Groundwater Transfer Review Summary Form

Transfer/PA # T- 13749

Application: T-13749

Applicant Name: Big Falls Ranch

Photograph of Cert. 76372 spring source taken by OWRD Watermaster (around July 13, 2021)

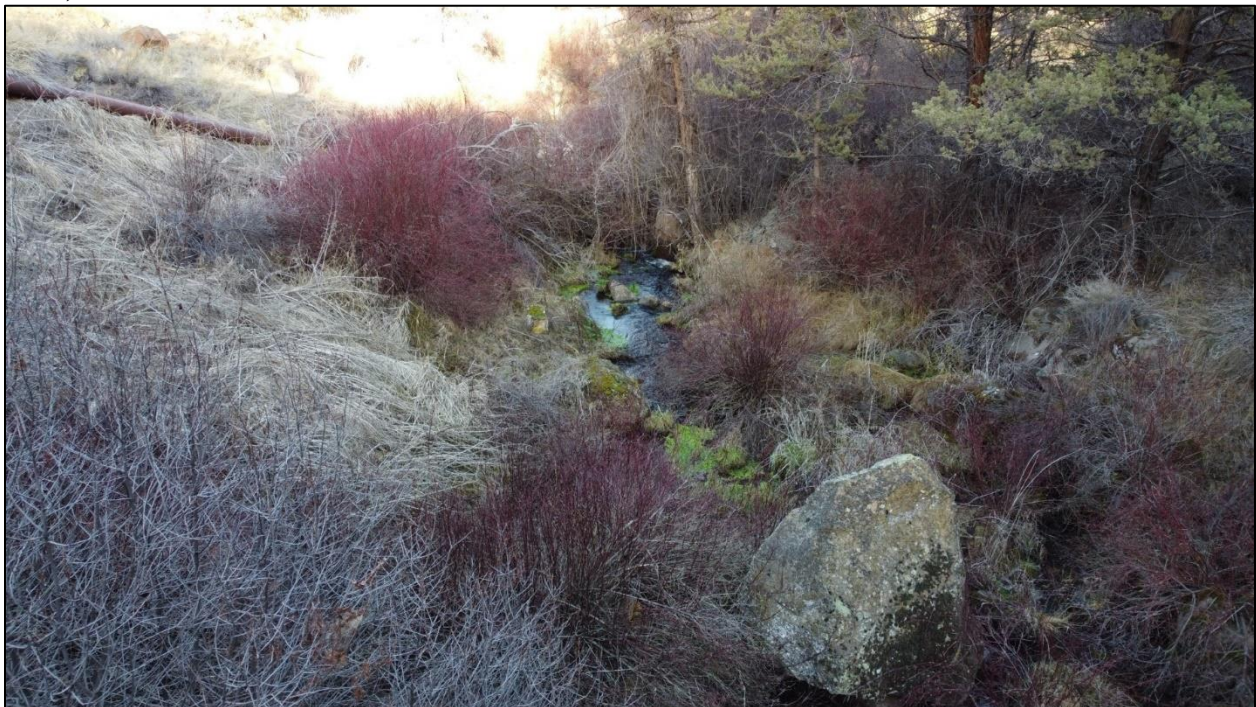
8. Any additional comments: The proposed change would move the point of appropriation from a spring discharging in the McKenzie Canyon to an aquifer system that may be intersecting both local and regional flowpaths. Water level data in one of the proposed groundwater PODs (DESC 768) shows a recent water level elevation of 2484 ft AMSL in 2020. The elevation of the spring is likely between 2420 and 2520 (the precise elevation is not available), which would be coincident with water levels in the well. Water levels in DESC 768 and other nearby wells show rates of declines of approx. 0.5 ft per year since the early 2000s but it is unclear if the declines in water levels in the aquifer are manifesting as reduced flow from the current spring POD, which would be expected if the spring was discharging from the same aquifer the wells were producing from. If the springs are not discharging from the same local aquifer zones as the proposed groundwater wells, then the groundwater wells would be producing from the regional aquifer system and intersecting flowpaths which discharge substantially at springs much farther to the north near the confluence of the Deschutes and Crooked Rivers. At the time of this review, however, there is not sufficient evidence that the groundwater wells are not producing from the same aquifer that the springs are discharging from and so the finding in Item 5 above appropriate.
